ARCHITECTURAL REVIEW BOARD MEETING

Thursday, April 27, 2023 at 7:00 PM

STAFF REPORT

Meeting Date:	April 27, 2023
Agenda Title:	COA 23-17 – 86 East Lee Street
Requested Action:	Review proposal for the construction of 7’ x 6’ portico at the front entrance of the building.
Department / Agency Lead:	Community Development
Staff Lead:	Casey Squyres

Proposed plan for new portico addition:

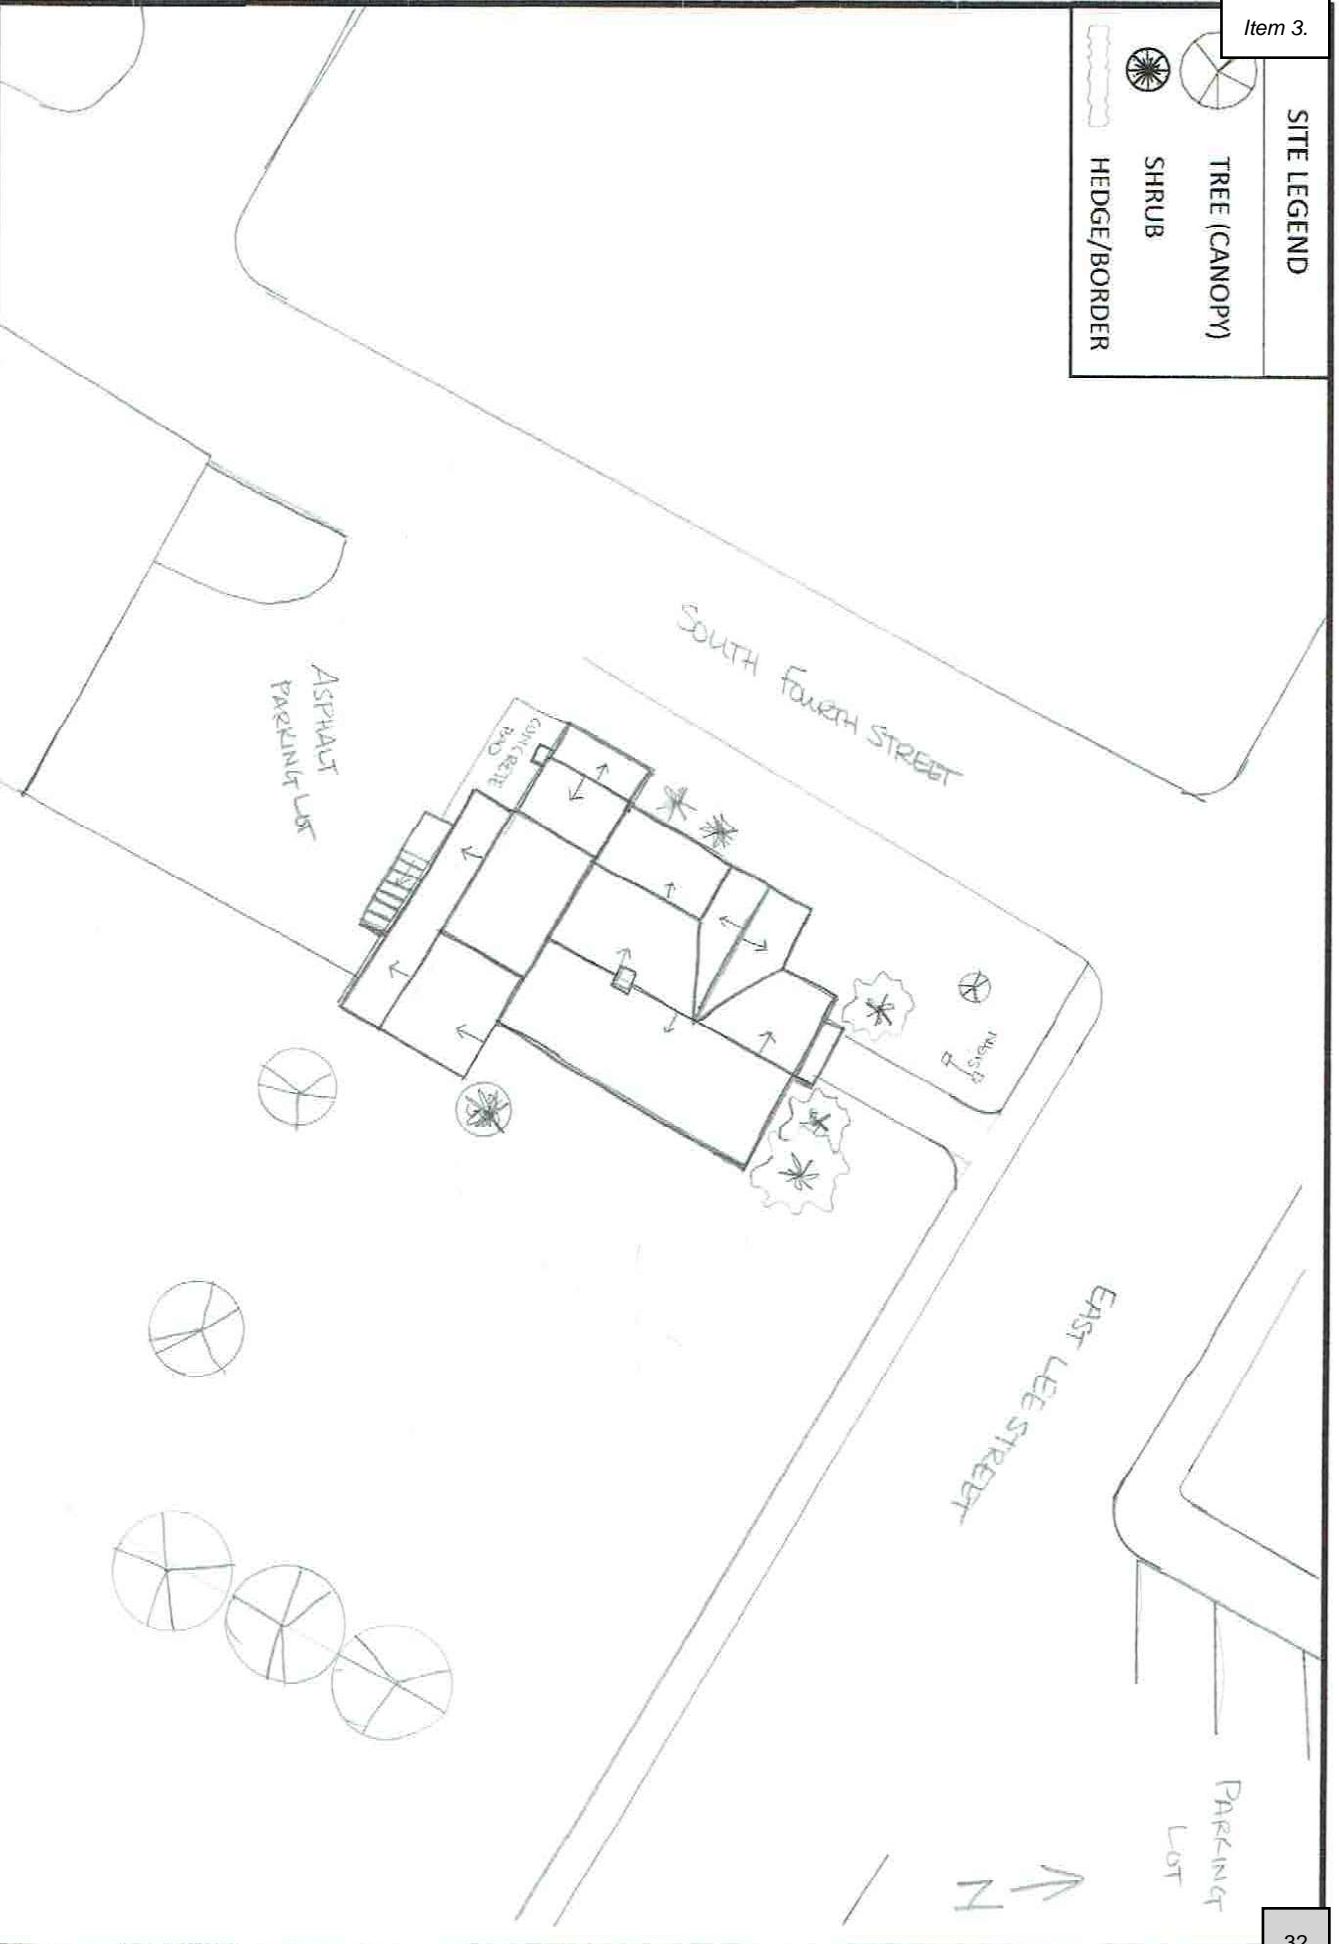
8. The style of the addition should not replicate the original but might respectfully, modestly reflect design elements.	3.72	The front-gable roof on the portico is a direct reflection of the main building and appears to impact the second floor window above it. Consideration of a smaller-scale front-gable roof or an extension of the existing shed roof may be more appropriate.

Historic District Guideline	Page No.	Analysis
10. Respect the size, proportion, spacing and rhythm of existing door and window openings on the existing building. Respect the spatial relationship between the wall surface and window opening of the existing building	3.72	No alterations to the existing fenestration is proposed nor does the portico installation impact the existing spatial relationship between the window and door fenestration on the first floor. However, it appears from the drawings provided that the front-gable roof of the portico may impact the second-floor window directly above it.

- 1) All necessary permits are acquired.
- 2) The second floor window must not be impacted or obscured by the installation of any portico.
- 3) Standing seam metal roof of portico must match color, gauge, and crimping style of main house roof.
- 4) The support posts must be wooden and reflect a design appropriate to the Italianate style.
- 5) The proposed railing of the portico must be either wood or wrought iron and simple in design, such as the square railing shown in the drawing.

FLOOR PLAN

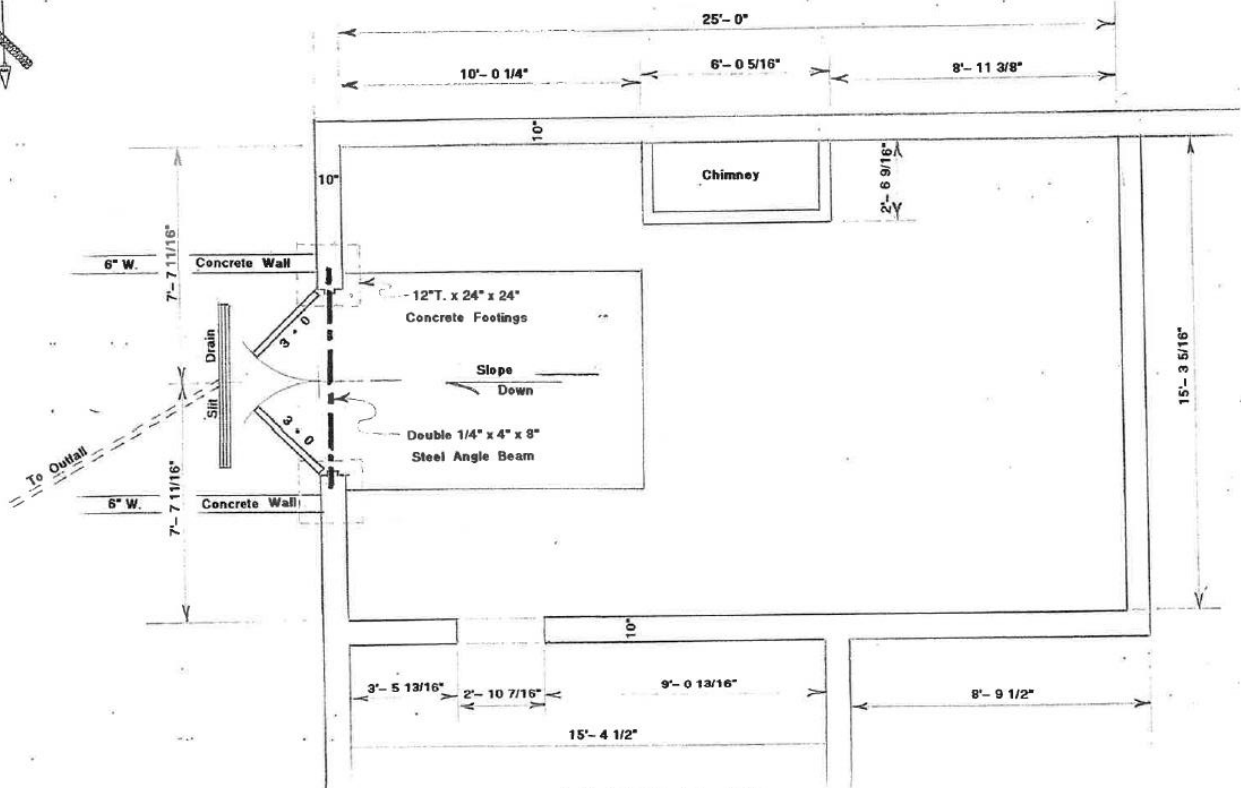
Historic District Guideline	Page No.	Analysis
B. Windows and Doors		
7. Design new windows, doors, and other elements to be compatible with the original building.	3.21	The proposed new door is located in an obscure location at the rear of the building and will not be visible.
8. Construct a new door or window when the historic feature is completely missing. It may be an accurate restoration using historical, pictorial, and physical documentation, or be a new design that is compatible with the size, scale, material, and color of the historic building. New windows and doors should also be compatible with the historic character and use of the building.	3.21	The proposed new door is located in an obscure location at the rear of the building and will not be visible.

Historic District Guideline	Page No.	Analysis
<p>9. Install additional windows or doors on façades of limited historic interest, usually only in minimally visible rear or side walls. Their design should be compatible with the overall design of the building. Locate new doors and windows to be consistent with the historic architectural style and rhythm of the building. Be careful not to significantly increase the amount of glazing as it will negatively affect the historic integrity of the building by changing the overall design of the building.</p>	<p>3.21</p>	<p>The proposed new door is located in an obscure location at the rear of the building and will not be visible. The door proposed is a paneled, metal fire door without windows that will measure between 40"-60" in width.</p>

Staff recommends approval of the request to install a new paneled, metal fire door (approximately 40"-60" in width) at the rear foundation of the building for the purpose of allowing egress from a mechanical room, provided the following conditions are met:

- 1) All necessary permits are acquired.
- 2) Install doors on façades of limited historic interest, usually only in minimally visible rear or side walls.
- 3)

Plans:

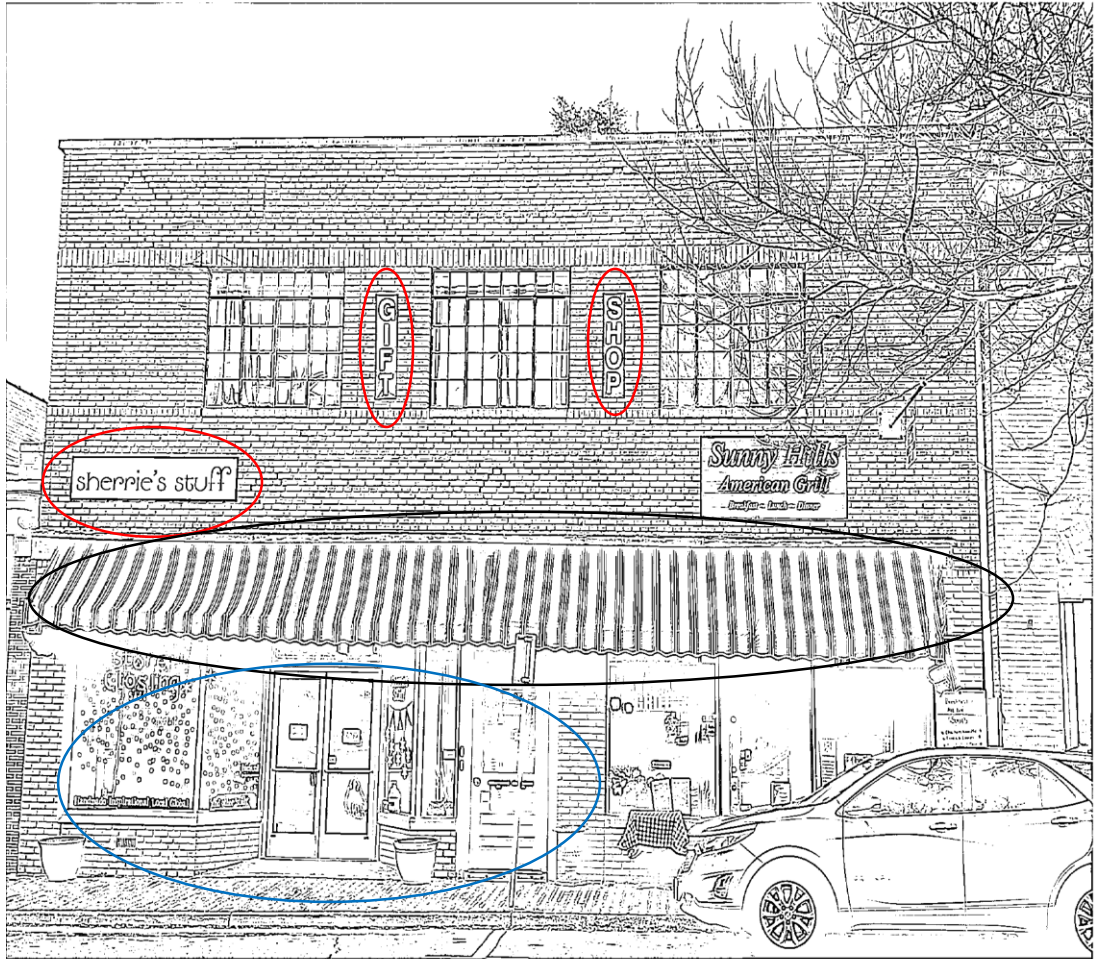
Existing signage to be removed circled in red

Existing awning (circled in black) to be removed and replaced with black Sunbrella awning

Existing trim (circled in blue) to be repainted in white from left to center of building

Staff recommends approval of the request to 1) install a new “Warrenton Market” sign measuring 2’ x 17’; 2) to repaint the wooden trim white as described, 3) to remove the three existing signs as described, 4) to remove the existing awning and install a new black Sunbrella awning in the same dimensions, and 5) to install vinyl lettering on the door as described and depicted in COA 23-22, provided the following conditions are met:

1. All necessary permits are acquired.
2. Wall signs should be attached in the least damaging means to the building’s materials and other character-defining features. Try to reuse earlier holes for mounting rather than making new ones. When new holes are necessary, always try to fasten into the mortar instead of compromising the strength of a brick.
3. No window sign should exceed twenty-five percent (25%) of the window area or have letters taller than twenty-four (24) inches. Glazed doors may also have lettering.

Water line installation will need to penetrate exterior of building:

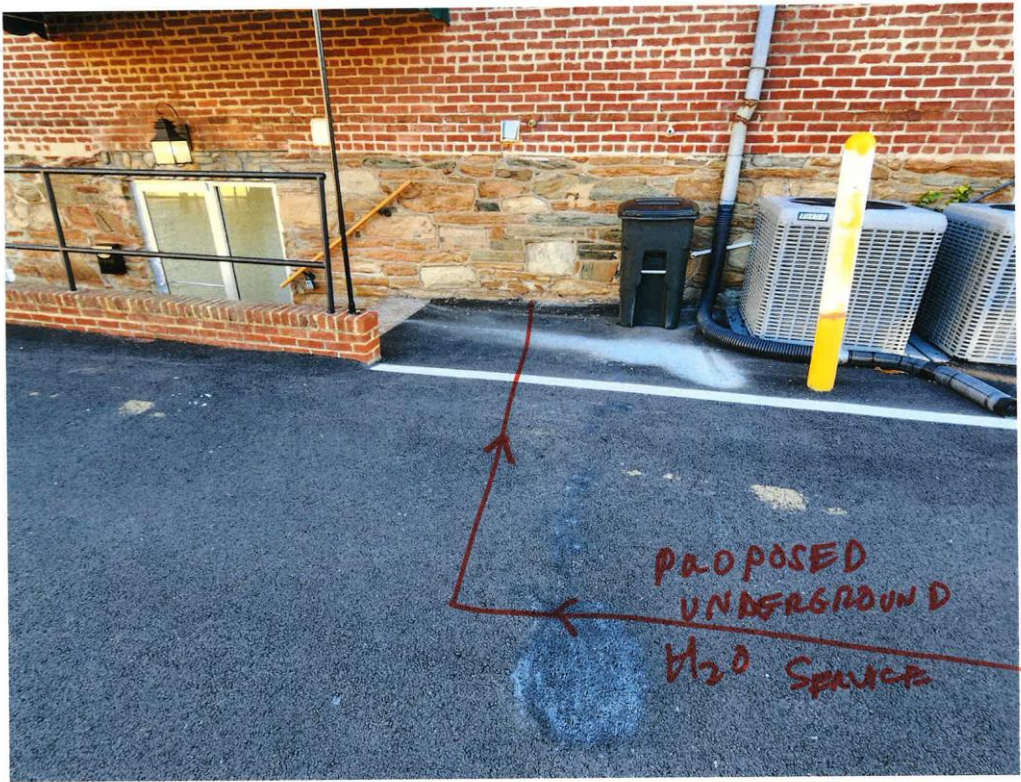
- 5) Additional information will be required for submission confirming the width and depth of the proposed water line, as well as additional detail describing any penetrations to the protected exterior of the building as a result of the water line installation, including dimensions of any holes that may need to be opened on the building.
- 6) Evaluate the least harmful means of inserting cable or pipe connections through masonry or frame walls of the building and implement the least damaging method.
- 7) Any exposed or visible HVAC lines should be painted or covered to blend with the exterior of the building.

- 5) Additional information will be required for submission confirming the width and depth of the proposed water line, as well as additional detail describing any penetrations to the protected exterior of the building as a result of the water line installation, including dimensions of any holes that may need to be opened on the building.
